Technical BULLETIN

2007 PZ50W/FXW/GTW/MW/VTW Hard Starting in Extreme Cold Temperatures

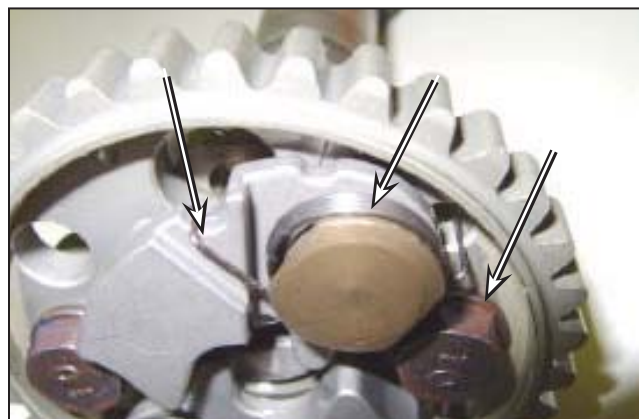
6. Remove the decompression spring as shown in the adjacent photo. Take care not to drop the spring into the engine.

7. Install the new decompression spring.

NOTE: Check that the spring is properly installed as shown in the adjacent photo.

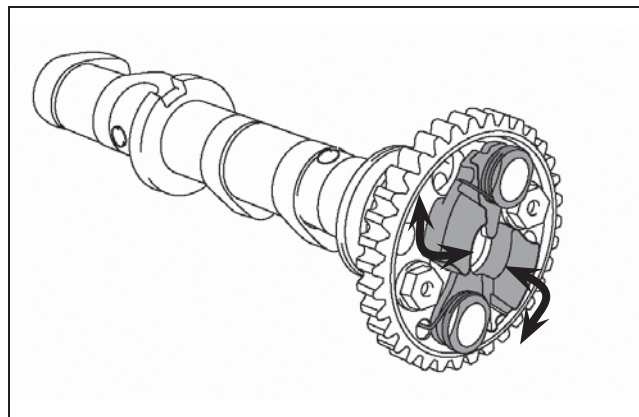
8. Using the primary clutch, turn the engine in the normal (clockwise) direction of rotation to access the other spring. Install the second spring.

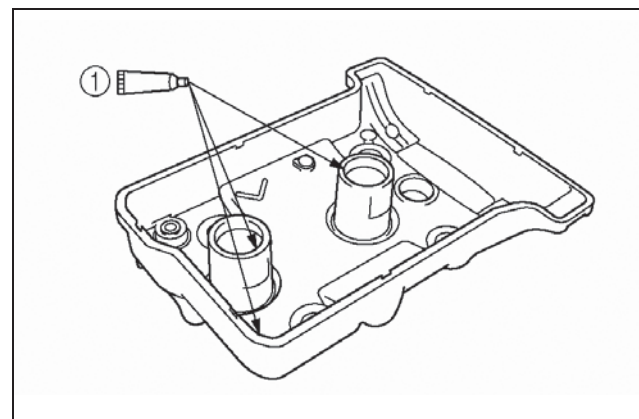
10. Re-install the cylinder head cover using the new gasket supplied in the kit.

Apply Yamabond 4 Motorsports to the cover ① surface and the mating surfaces of the cylinder head cover gasket and cylinder head ②.

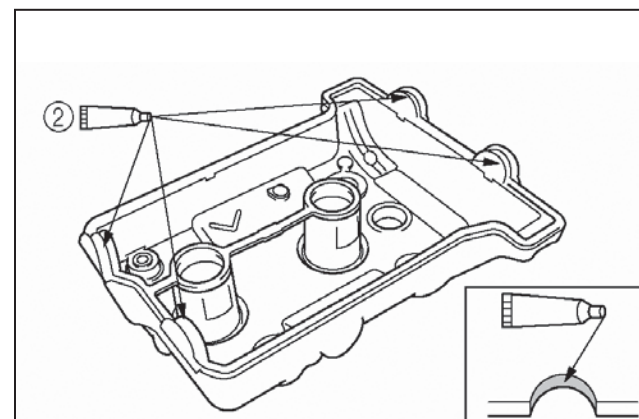
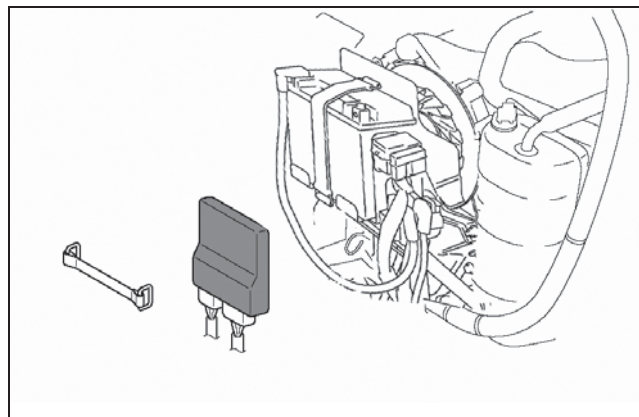
Tighten the cylinder head cover bolts in gradual steps and in a crisscross pattern.

**Cylinder head cover bolt tightening
torque:
12 Nm (1.2 m•kg, 8.7 ft•lb)**

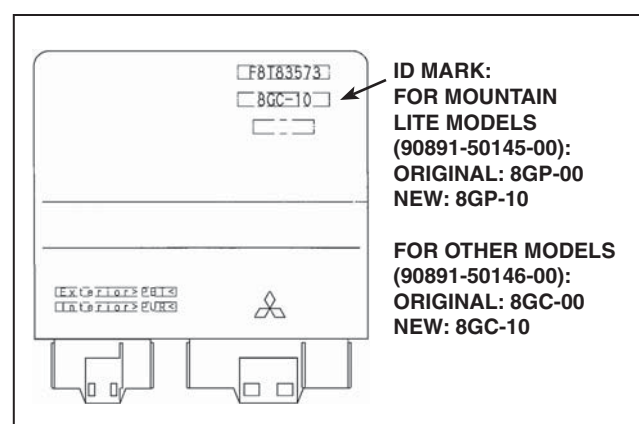
If you encounter an unfamiliar unit and you are unsure if the unit has been modified, check the ECU (see adjacent illustration).
